1 **Supplemental Information**  
2 **on**  
3 **454-010 or 27H9612 OVERRIDER, WITH BOLT**  
4 **AHY 100-4, MG TD, TF, BUGEYE SPRITE**

*Unchromed pre-production sample on an NOS Healey 100 (left) and an NOS Sprite facebar (right).facebar.*

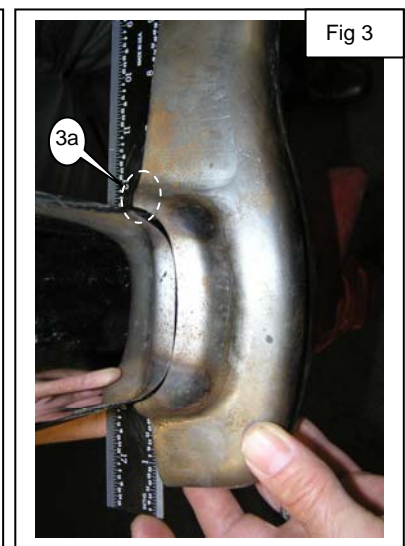
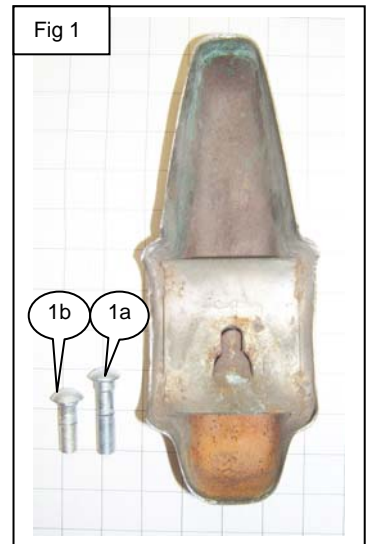
14 We originally produced the 454-010 override with a captive nut welded to a plate  
15 that was in turn welded to the override. In production, the plate was difficult to  
16 position perfectly and the angle of the installed override depended on exactly where  
17 the captive nut was and the precise angle of the facebar. If the facebar was canted  
18 the least little bit, the override leaned either forward or backwards. It was a lot more  
19 noticeable with the override than the facebar. Because the nut was fixed in place,  
20 there was not a lot that could be done. As we tried to come up with a fixture that  
21 could be used in production to properly locate the captive nut, we found that an  
22 override that fit a T Series facebar just fine could not be fitted to a Sprite or a  
23 Healey. At that point we abandoned the idea of a captive nut and we started over.

30 We found that the slot provided a wide range of  
31 adjustment. Although the bolt did not move, you could  
32 move the override up or down quite a bit and tighten  
33 the nut when you were happy with the way it fit. We  
34 decided to re-tool the override using the slotted  
35 mounting plate. We also reshaped the curved edges  
36 (2a) to more closely follow the facebar.  
37

38 In June 2007 we received our first unchromed pre-  
39 production samples of the new overrides. We fitted the  
40 samples on an original Healey facebar (Fig 2) and an  
41 original Sprite facebar (Fig 3) without the override  
42 packing (400-418) so we could better judge the fit. We  
43 also fitted them to the facebar on the Moss TD "pickup"  
44 and a selection of replacement facebars. The sample  
45 overrides could be installed on a Sprite, MG TD, and a  
46 Healey 100 without any trouble using a 3/8" carriage  
47 bolt 2 inches long.

49 The newly retooled overrides and pressed from steel plate, and the edges are cleaned  
50 up by hand. The plates with the slot for the carriage bolt are pressed separately. The  
51 outer shell and the plates are assembled in a fixture that precisely locates the plate, and  
52 the two pieces are welded together. The override is chrome plated, and the back of the  
53 override is painted silver, which is how all bumpers and overrides were done by the  
54 factory. In September of 2007 we received our first shipment of the redesigned 454-010  
55 overrides. We test fit them again, just to confirm that nothing had changed (and they  
56 still fit fine). The correct bolts for the Healey would be 7/16 UNF (20 TPI), and we do not  
57 have a source at this time, and we are not certain that the bolts used on the Healey  
58 would be correct for the MG TD & TF or the Sprite, which used a 3/8" UNF bolt. The

59 overrides are supplied with one somewhat generic 3/8" UNC (16 TPI) x 2" carriage  
60 bolt. If you are fitting these to the front facebar on a 100-4, the carriage bolt supplied  
61 may be too long and it may show behind the facebar. If so, it can be shortened. There is  
62 a slight difference in the shape of the rear edge of the override where it meets the top  
63 of the face bar. On ours, the back edge (3a,5a) runs from the top to the facebar in  
64 nearly a straight line, and on the Healey at least, these edges angled forwards a bit  
65 near the face bar. We have tried to balance the features of original Sprite, T-series and  
66 Healey overrides while designing something that was practical to make.
